RESPONSES TO COMMENTS ON THE SUPPLEMENTAL EA/RECIRCULATED DRAFT EIR SECTIONS

The Regional Connector Transit Corridor Project Supplemental Environmental Assessment/Recirculated Sections of the Draft EIR (Supplemental EA/Recirculated Draft EIR Sections) was made available to identified stakeholders, agencies, and the general public for review and comment for a 45-day review period from July 22, 2011 through September 6, 2011.

This volume of this Final EIS/EIR contains copies of all written comments and provides written responses to all comments received on the Supplemental EA/Recirculated Draft EIR Sections. A total of 31 comment letters were received during the public review period. Overall, a total of 263 individual comments were received on the Regional Connector Transit Corridor Project Supplemental EA/Recirculated Draft EIR Sections.

FIGURE 1
Regional Connector Transit Corridor Project
Sewer Map

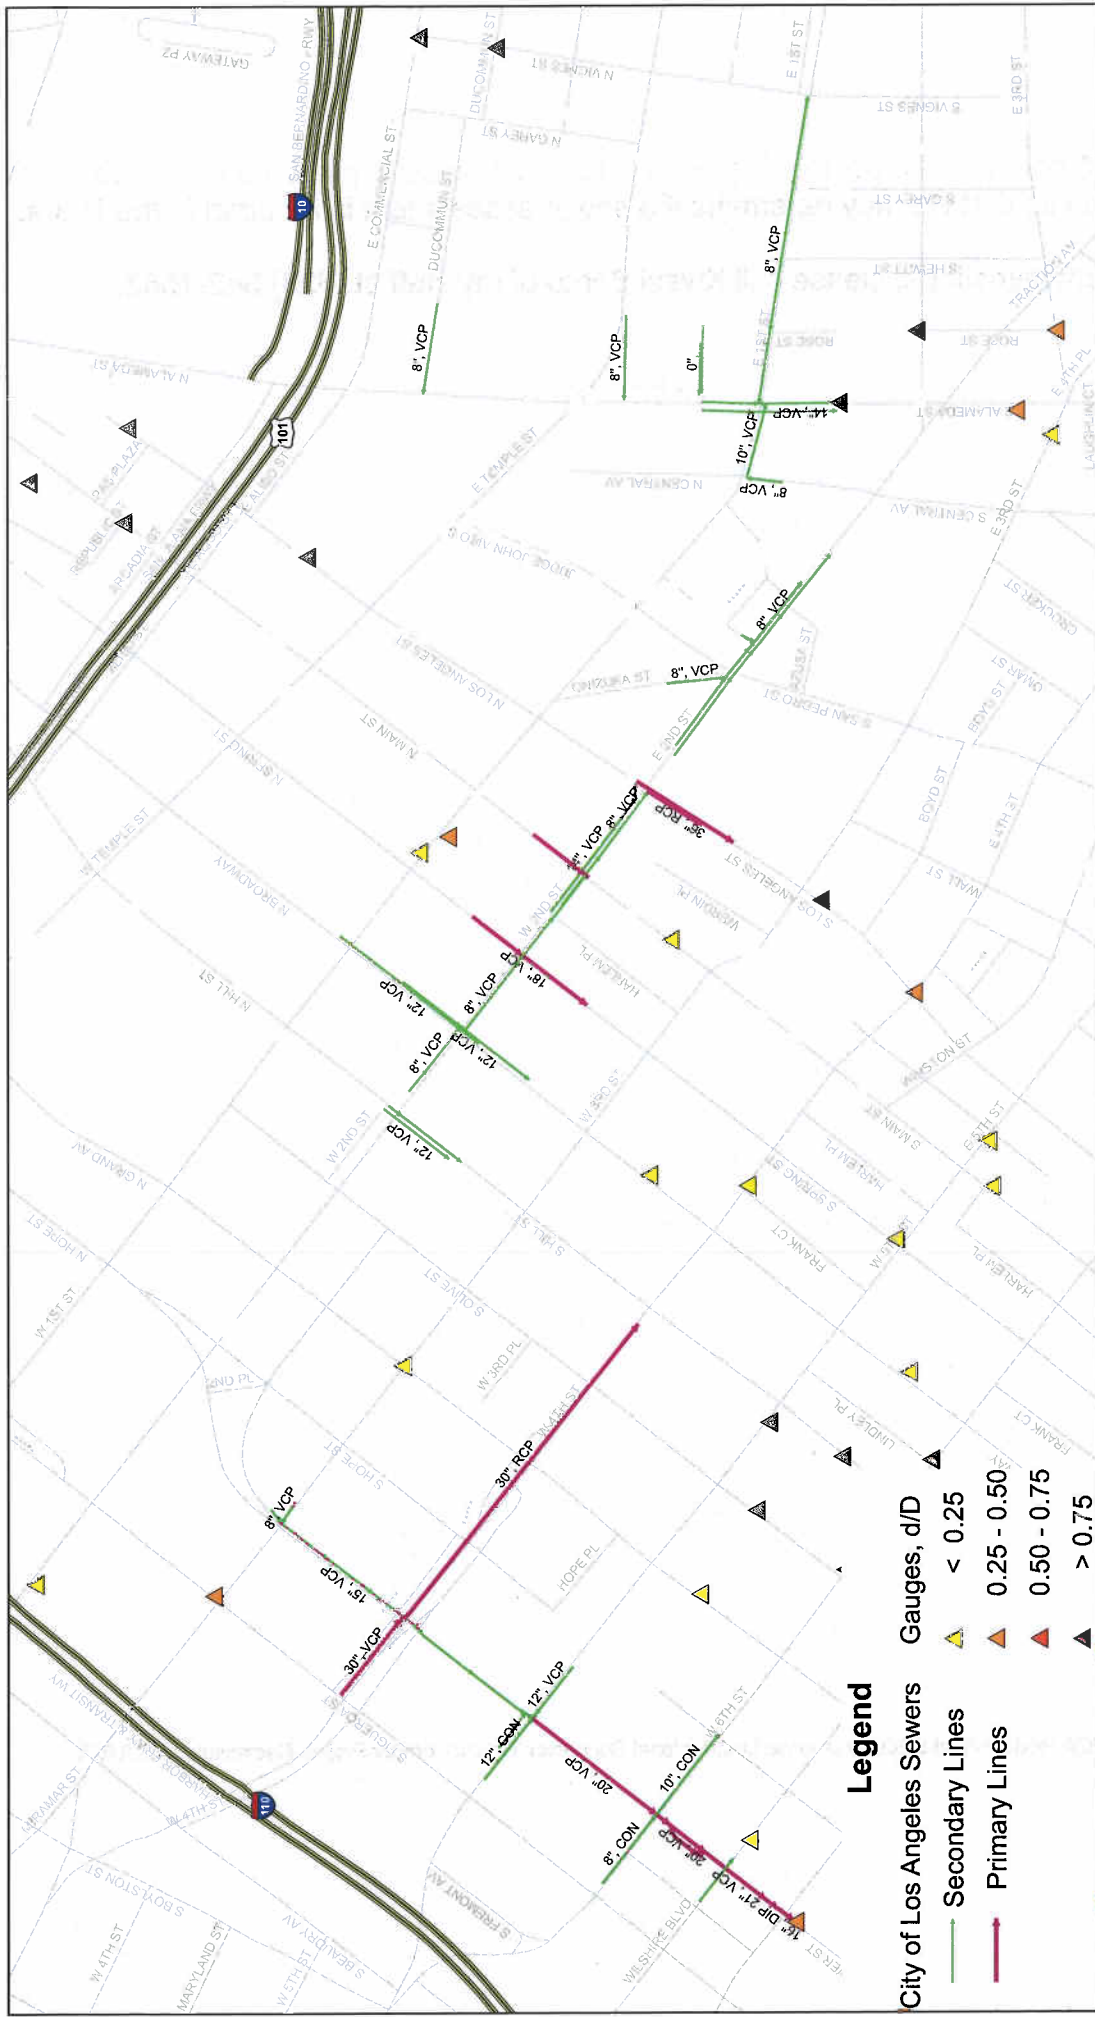
The majority of sewer lines within the proposed project area consist of secondary lines. The secondary reaches run along W 7th St, S Hill St, E Cesar E Chavez Ave, E Commercial St, and S Alameda St. The primary sewer reaches run along Flower St, E Cesar E Chavez Ave. and Alameda St near the 7th St/Metro Center, Union Square, and the Little Tokyo Stations, respectively. Gauging within the project area show relatively low flows which indicates the existing sewer system might be able to accommodate future discharges related to this project. Figure 1 shows the existing sewer lines and gauging locations along the alignment of the proposed project.

ORIGINAL NO. C0980
 DRAWING NO. SG-001
 SCALE 1" = 50'
 SHEET NO. 19

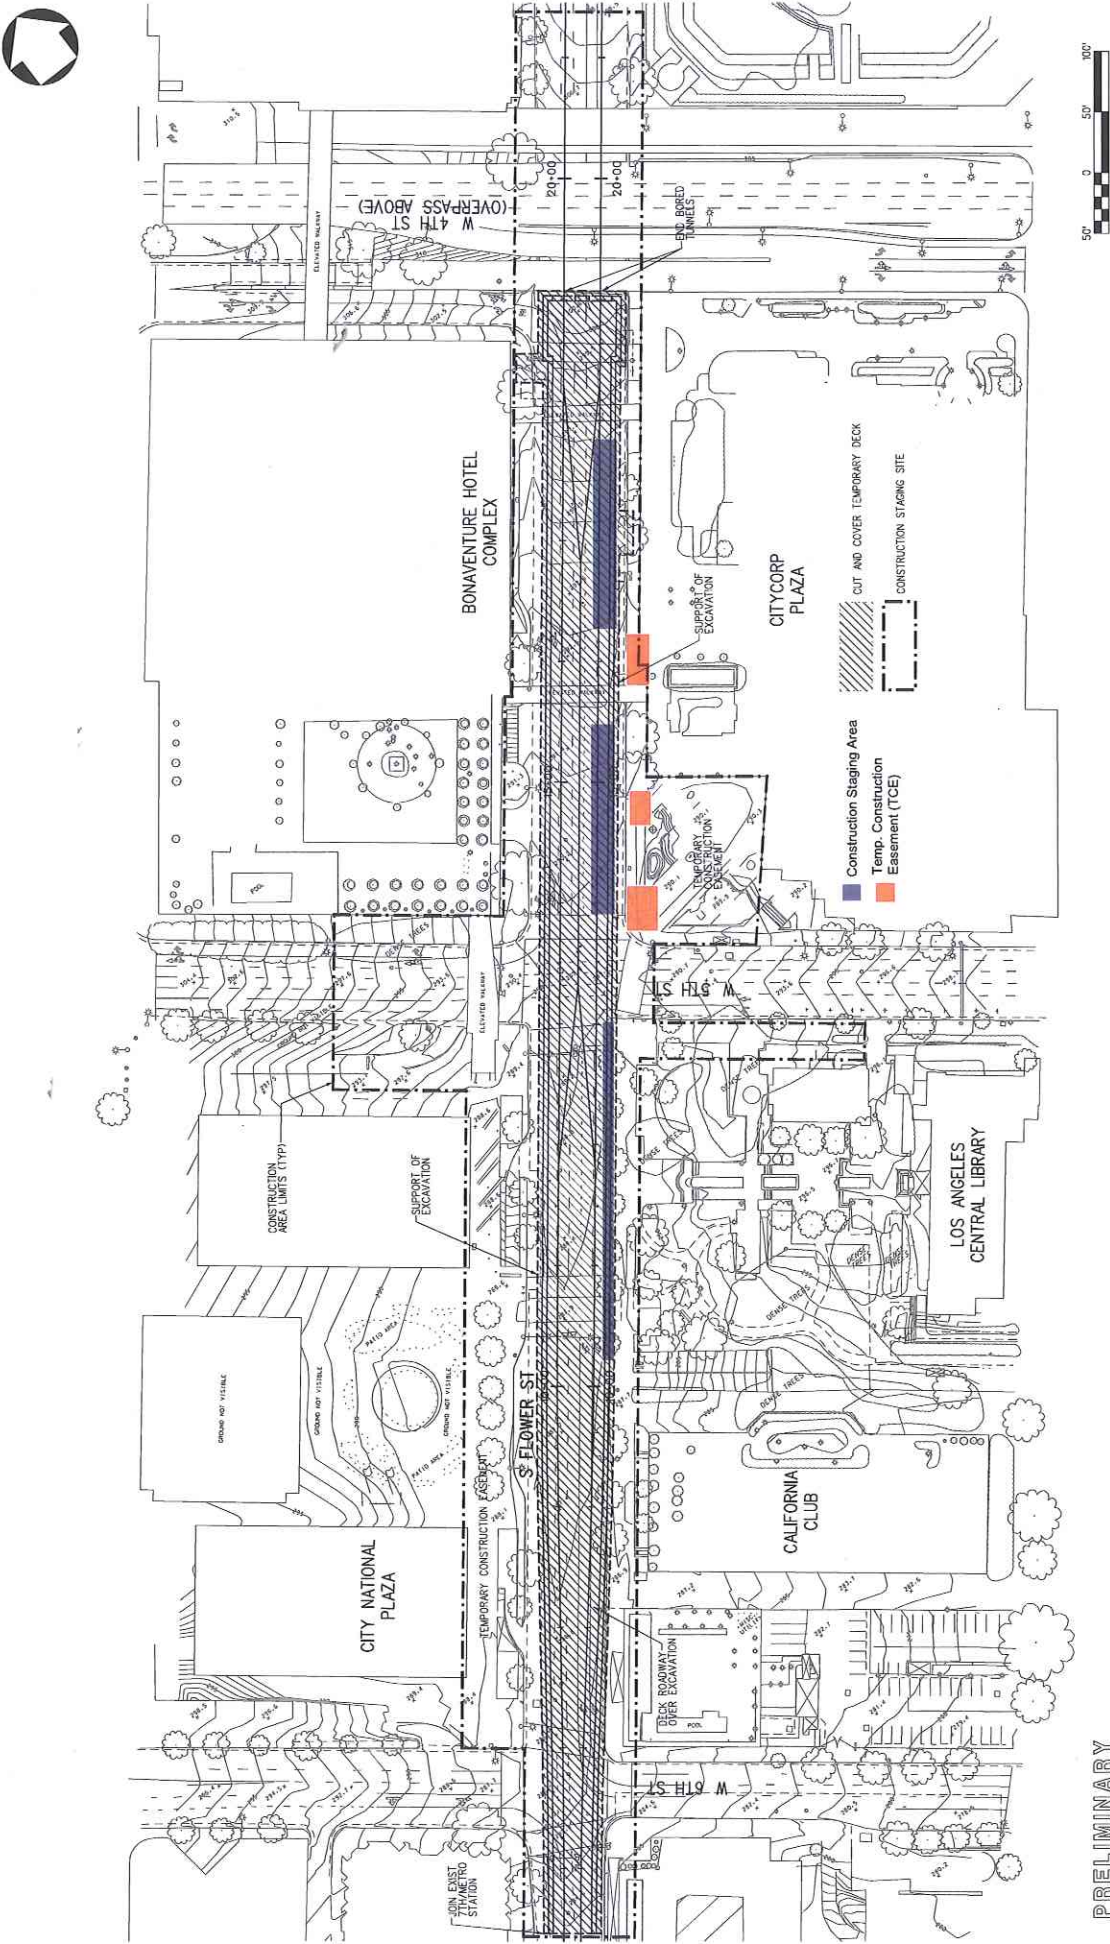
Attachment: "Construction Area Plan Structure Cut and Cover" Site Plan

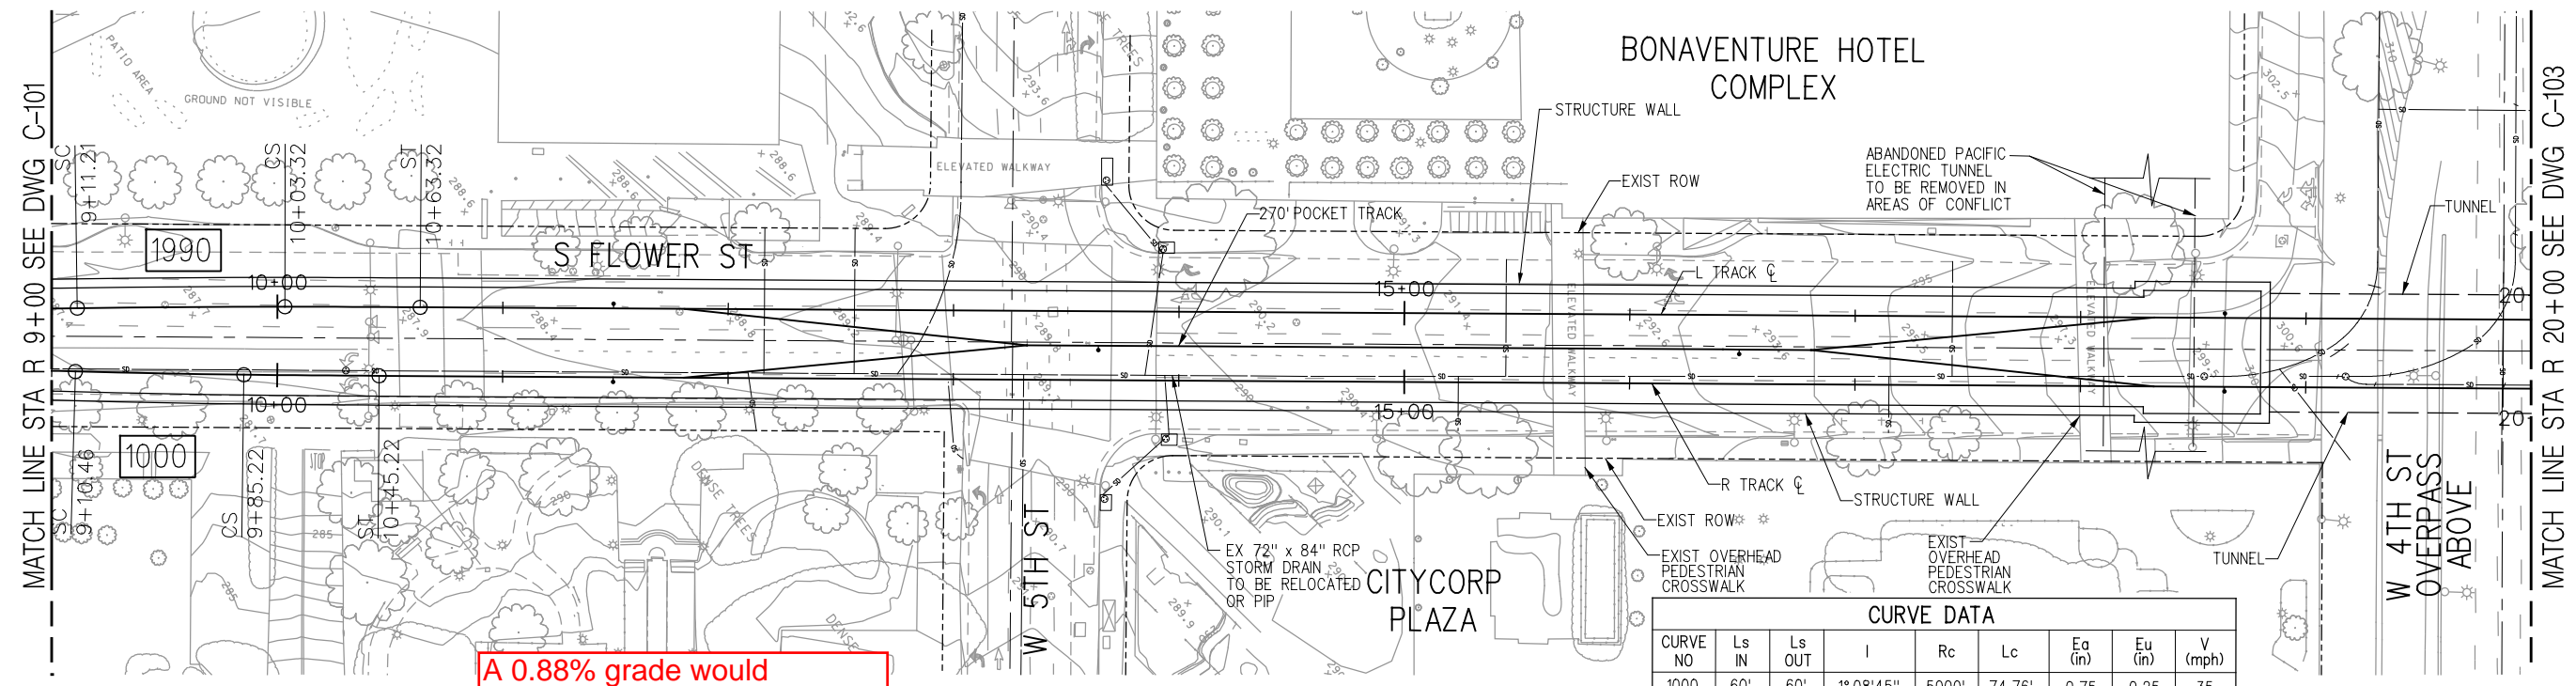
- A pocket track, which could also serve as a crossover, would be located beneath Flower Street between 5th and 6th Streets. This would allow for a possible future station at this location to be constructed as a separate project.
- Crossovers could be located north and east of the proposed rail junction: in the tunnel beneath the Mangrove property, and beneath 1st Street just east of the intersection of 1st and Alameda Streets.
- A traction power substation (TPSS) facility would be located along Flower Street between 5th and 4th Streets in the deleted Flower/5th/4th Street station location.
- Antennas may be used as part of the LRT communication system. Antennas would not be visible from any historic resource and would not intrude on the visual quality of the surrounding neighborhood (refer to Section 2.3.3.7 herein below for more information).

Would preclude a future 5th/Flower Station

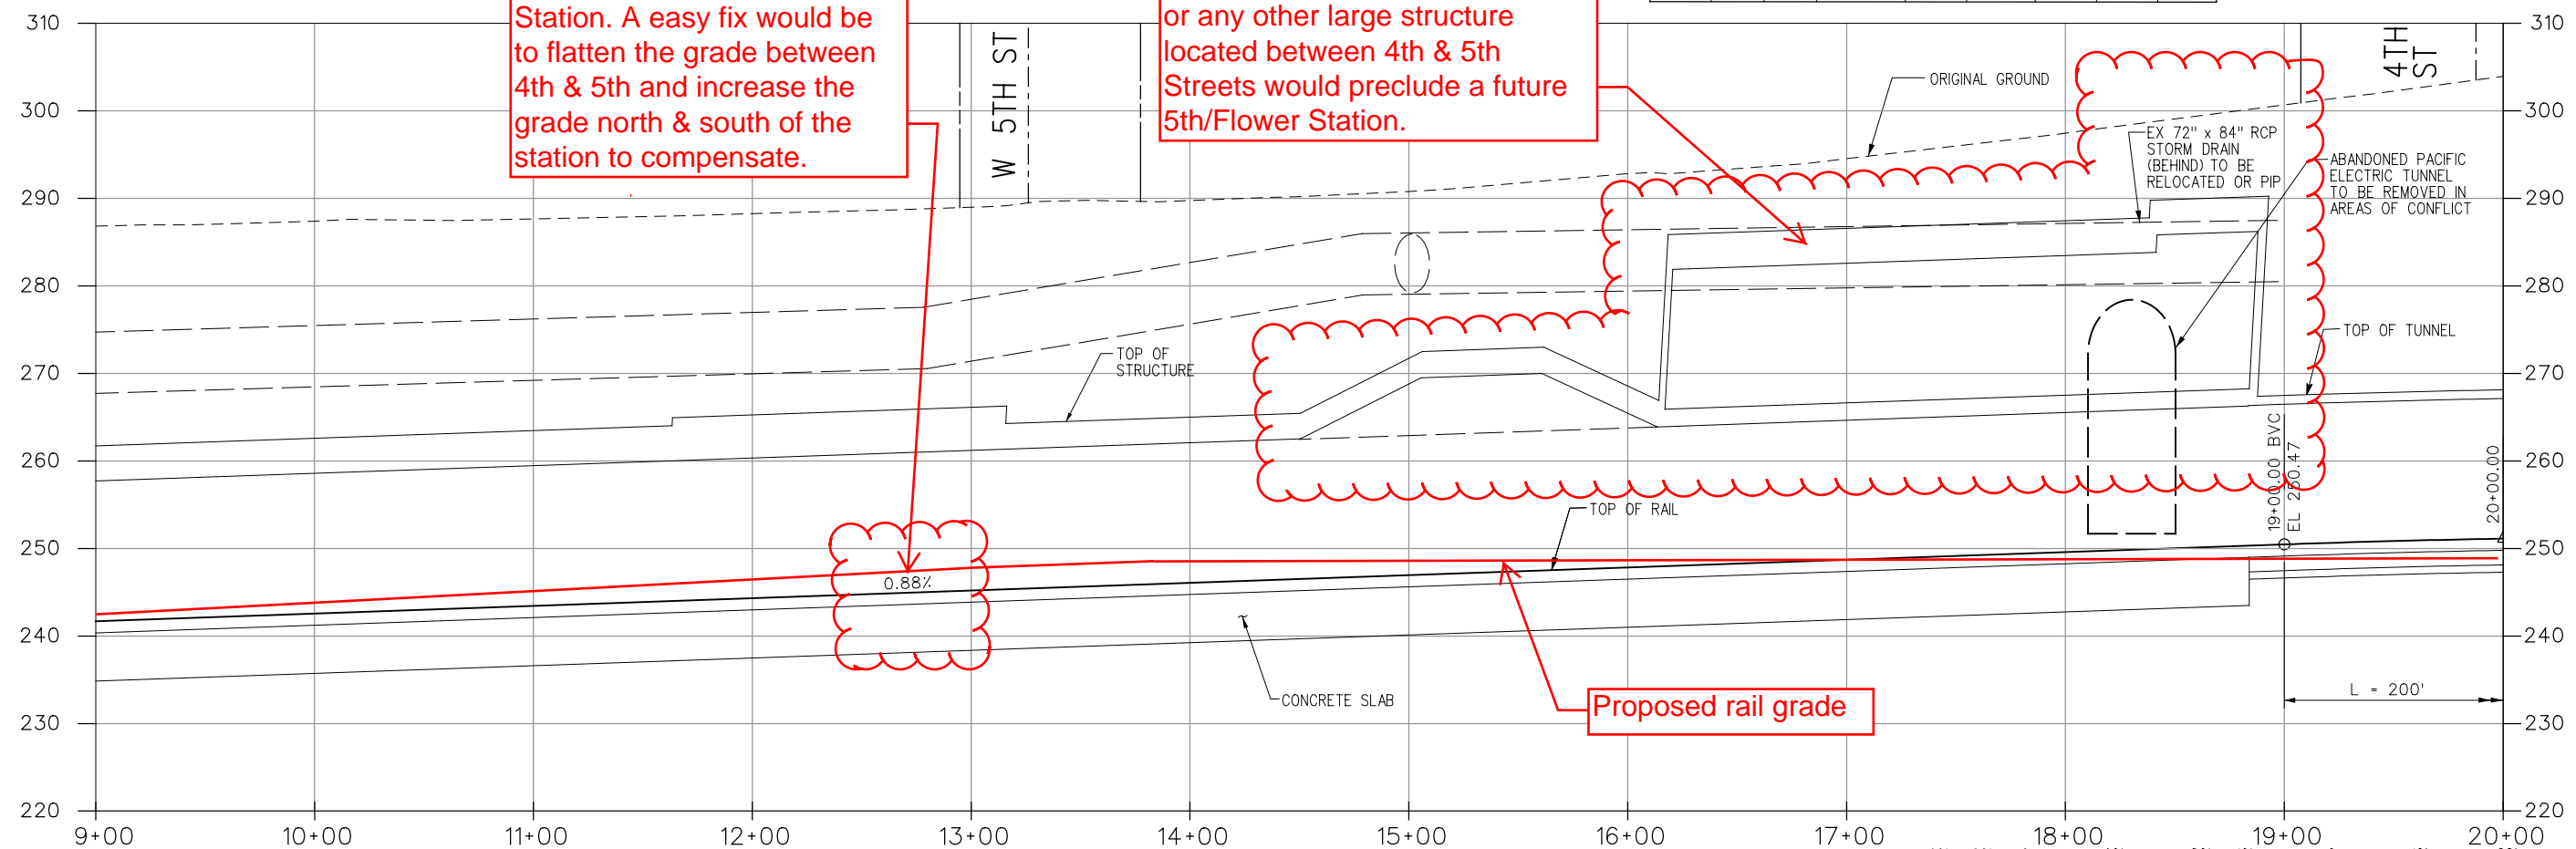
A 0.88% grade would preclude a future 5th/Flower Station. A easy fix would be to flatten the grade between 4th & 5th and increase the grade north & south of the station to compensate.

A traction power station (TPSS) or any other large structure located between 4th & 5th Streets would preclude a future 5th/Flower Station.
